NUMBER: 23-048-17

Instrument Panel Center Storage Drawer Binding

This bulletin involves removing the felt tape from the center storage drawer to prevent binding.

Chrysler Pacifica

Fig. 3
Torsion Spring

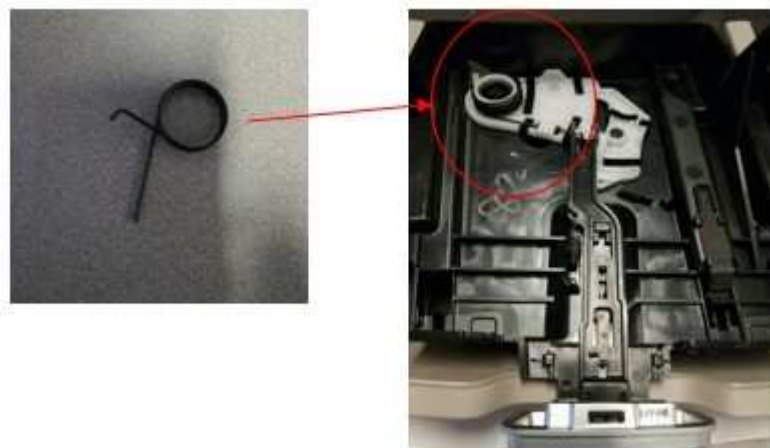
a. Remove the torsion spring (Fig. 3) .
